Application for a Section 5 Declaration
Development / Exempted Development

Re: Application for a Section 5 Declaration – Upgrade of windows to triple glazed UPVC units and replace the existing timer front door to a composite front door at 18 Main St., Templemore, Co. Tipperary.

Planning Ref.: S5/24/149

Planning Report

Figure 1: South-east elevation of subject building in June 2024

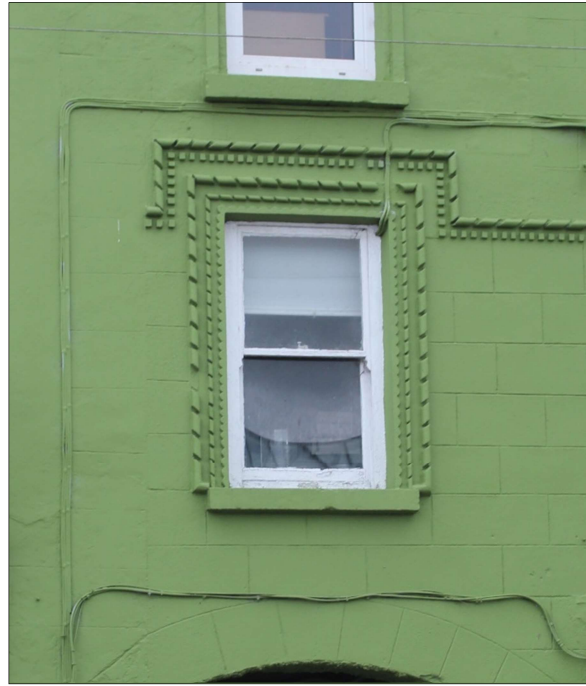
The Planning Authority advises that in order to better compliment the traditional architectural form of the terraced building and the wider nineteenth-century streetscape which lends the Patrick Street ACA its distinctive character, there is a preference for replacement windows to be of hardwood timber and bespoke design. These would replicate the historic pane arrangement of the sliding sash windows typical on such a nineteenth-century streetscape with the traditional, fine dimensions of glazing bars and mid-rails along with simple moulded details that should reference the detail of surviving, historic window frames elsewhere on the Main Street (see *figure 2* below). Slim (<14mm thick) double-glazing units could be incorporated along with discrete draft-proofing of new timber window frames, and guidance for manufacturing design of same could be sought from the planning authority.

The desire for triple-glazed windows is likely to be unworkable in a timber sash window arrangement without requiring significant, unsightly increase in the dimensions of the timber frame to carry the extra weight of glazing and deeper glazing rebates. For this reason, a uPVC frame would be acceptable as no historic windows are present on the building. Any new windows should have the traditional arrangement of one-over-one or two-over-two panes with a **central**, horizontal mid-rail to replace the existing inappropriate three-pane arrangement.
